Henry Flats Cluster Subdivision

Henry Flats Cluster Subdivision
 PART OF THE NE 1/4 OF SECTION 17, T.6N., R.2W., S.11B & M., U.S. SURVEY
 WEBER COUNTY, UTAH

Preliminary Submittal

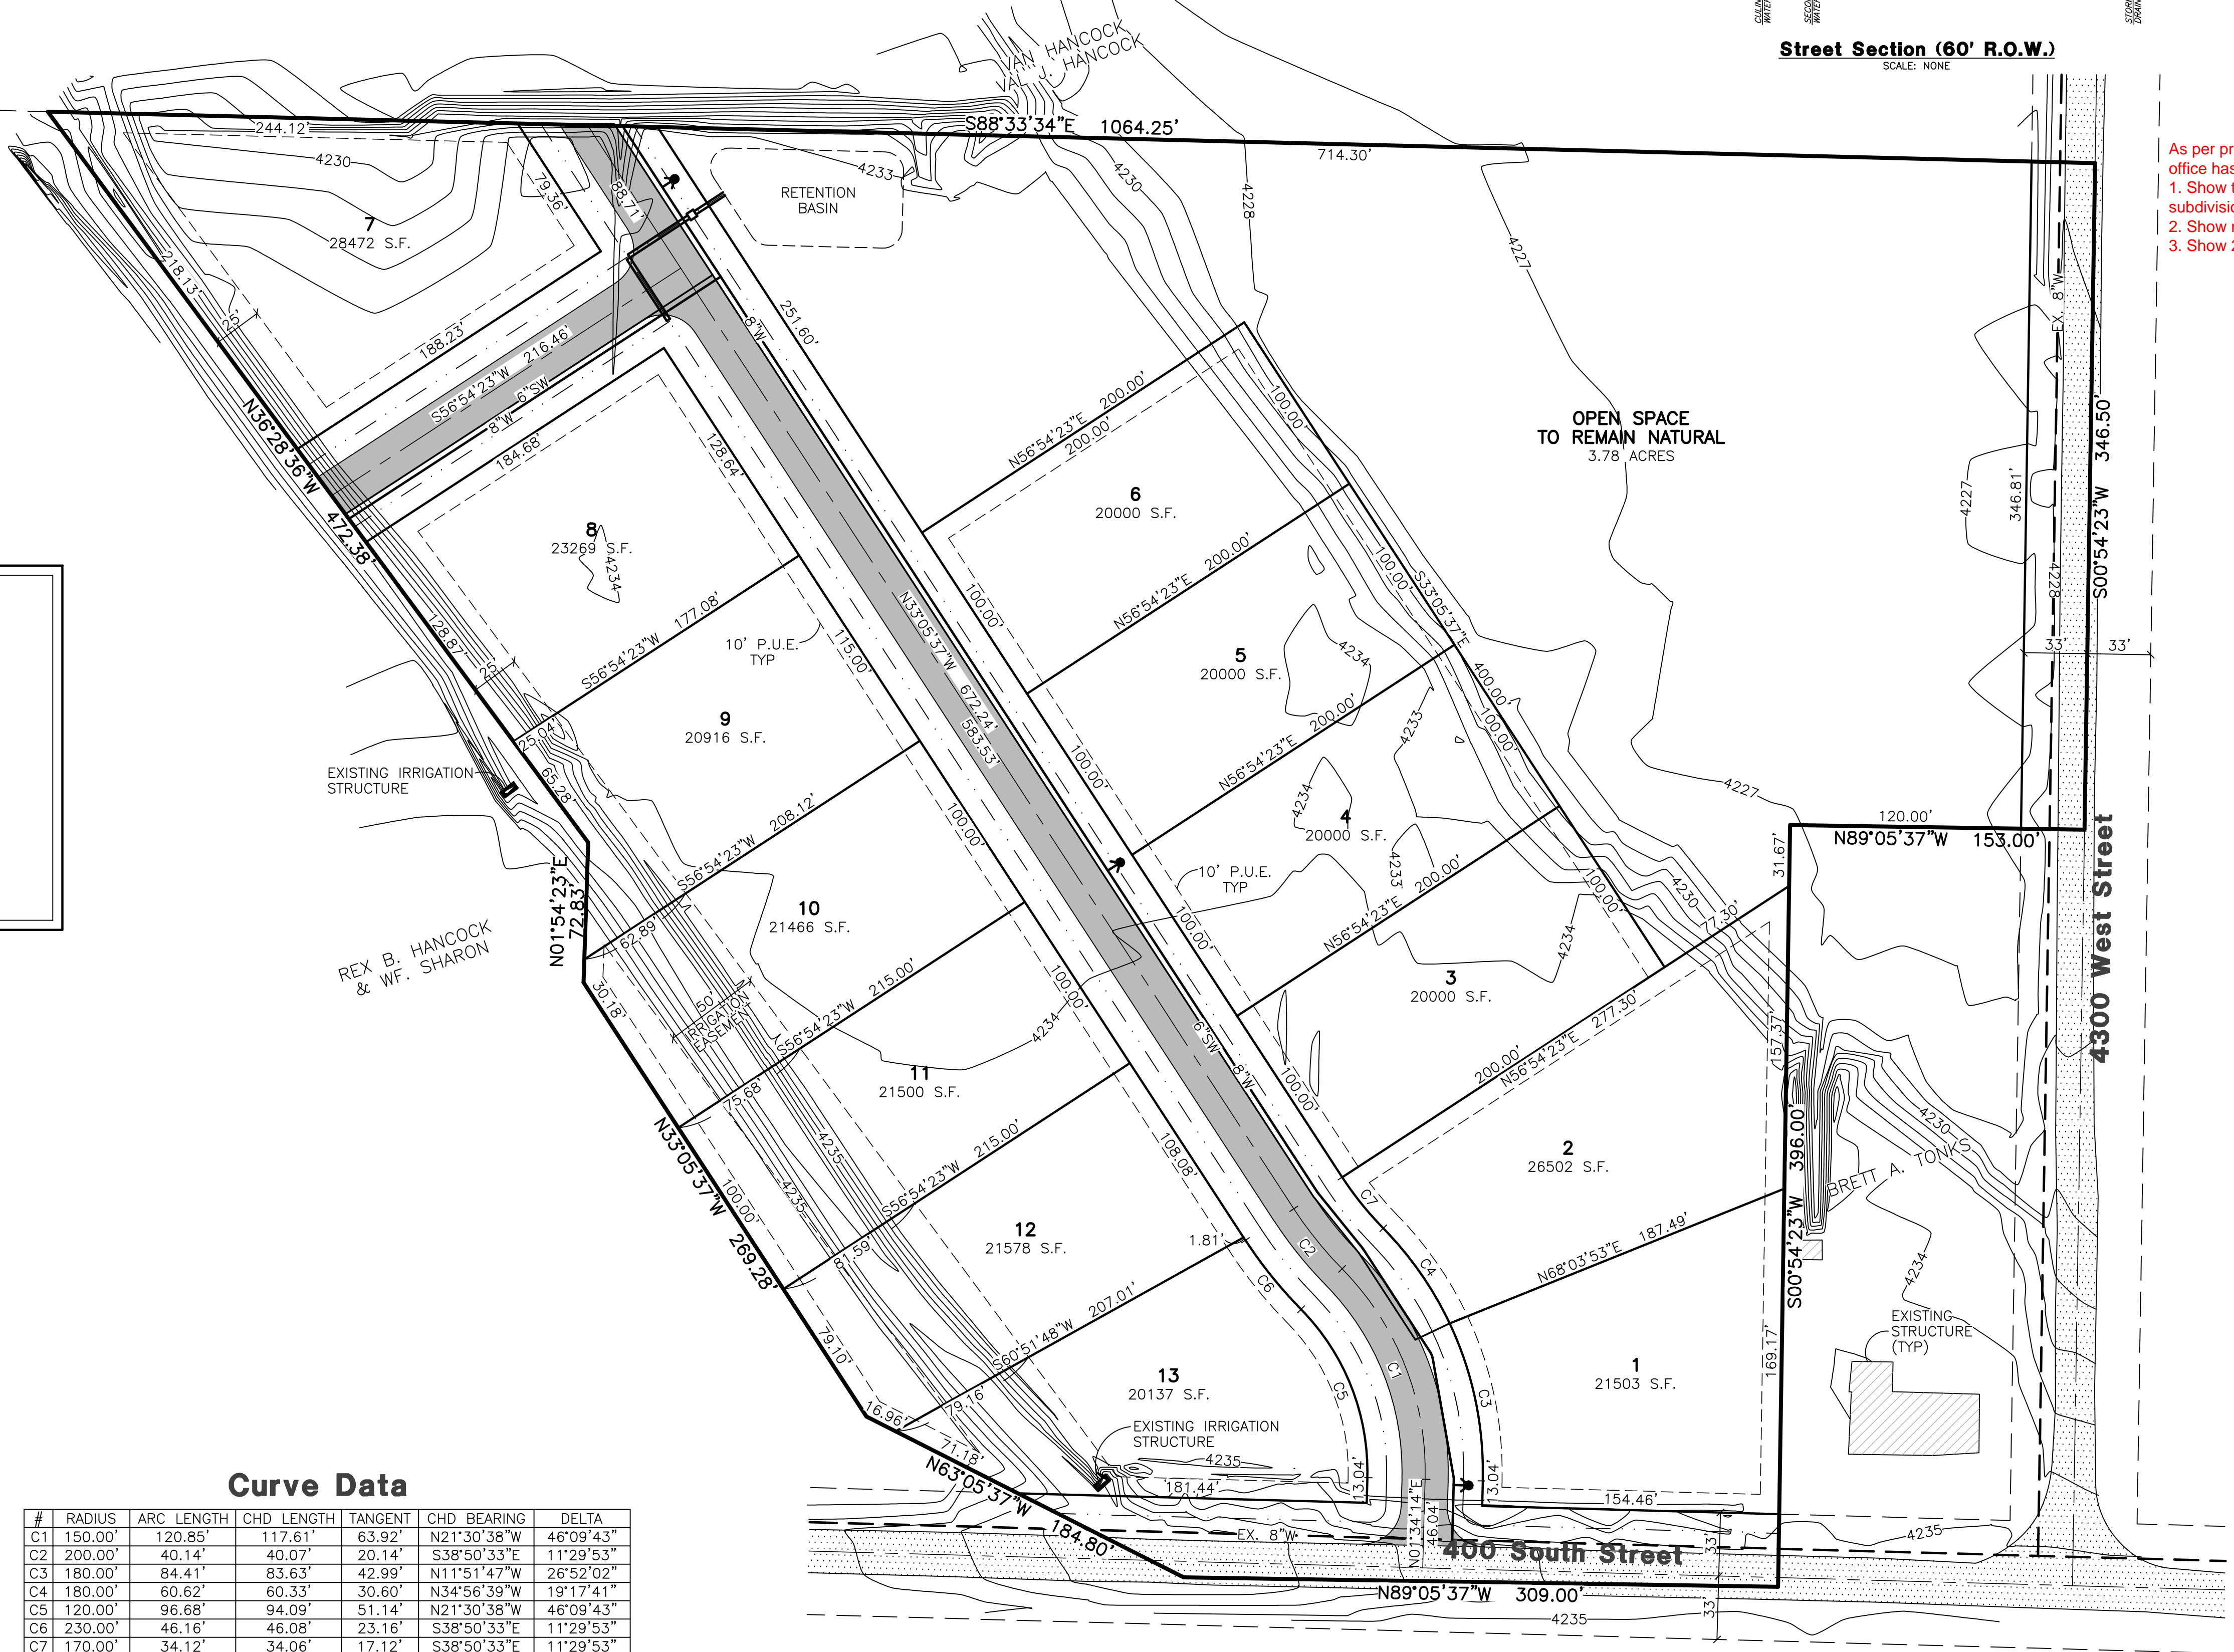
- As per preliminary plat requirements, this office has the following comments.
1. Show ties to monuments to locate subdivision
 2. Show names of engineer and surveyor
 3. Show 2' contour interval
